U.S. NUCLEAR REGULATORY COMMISSION

Docket/Report: 50-317/88-01
50-318/88-01

Licensee: Baltimore Gas and Electric Company

Facility: Calvert Cliffs Nuclear Power Plant, Units 1 and 2

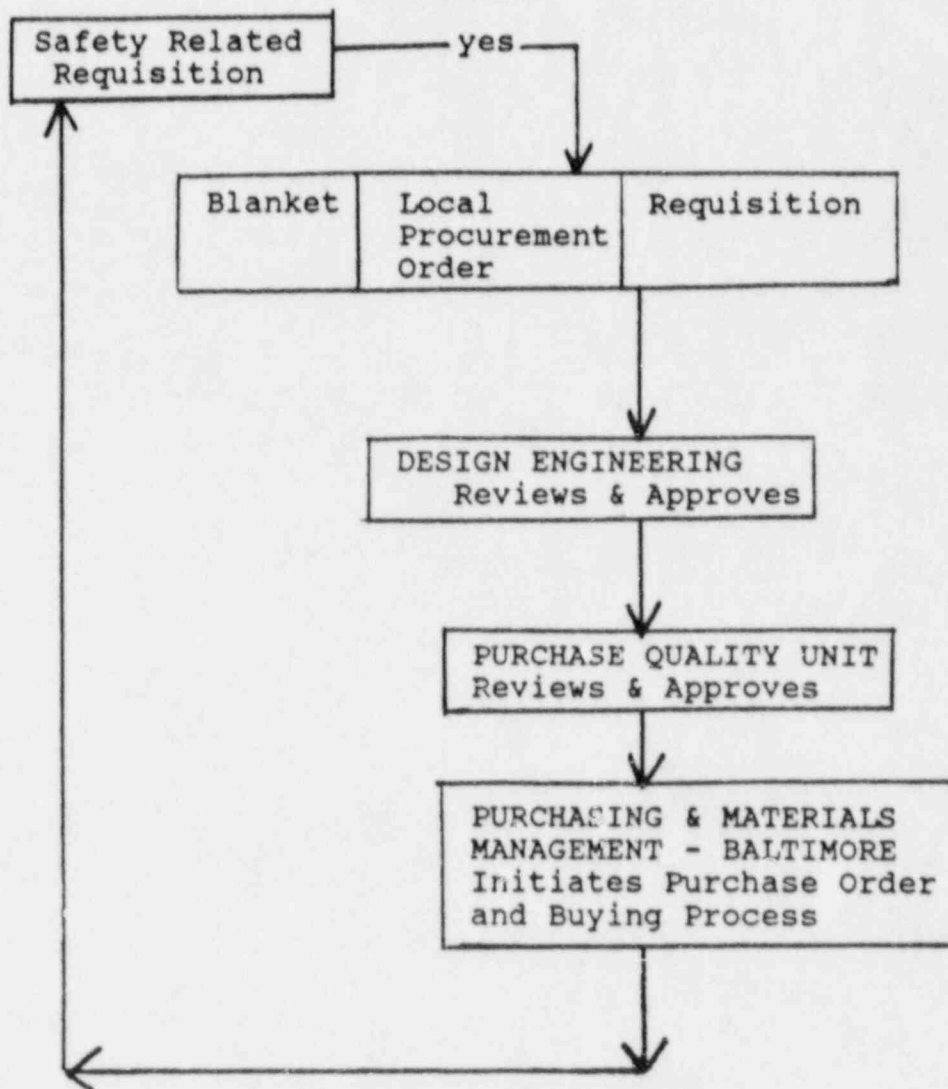
A feedback communication interface problem exists. The EPC does not communicate the status of the requisition to the PCCU. The PQU does not communicate the status of the requisition to the EPC or PCCU. The PCCU learns of the requisition status only after Baltimore cuts a purchase order. This process may take several weeks. (See diagram).
